RE: Recall 04V088

VEHICLE SAFETY DEFECT SERVICE BULLETIN

Recall Campaign No. 04V088000

Re: Recall- Federal Id Label – Incorrect Rim Size

Recall Repair Procedures

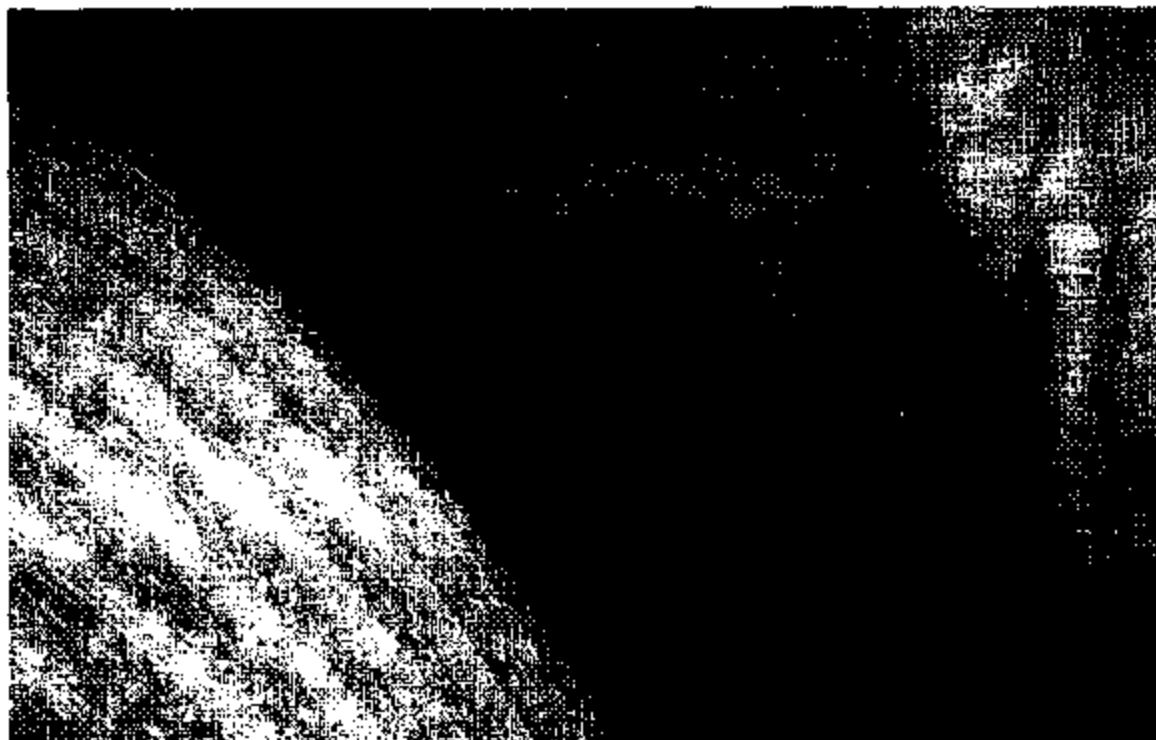
Monaco Coach Corporation has become aware that the Federal Identification Tag was printed with an incorrect rim size. The initial tag states the rim size as 22.5X6.75G Range when the correct rim size should be 22.5X7.5F Range.

The label is located on the roadside sidewall, directly to the left and rear of the driver's seat as illustrated above. Install new Federal Certification Label over existing label.
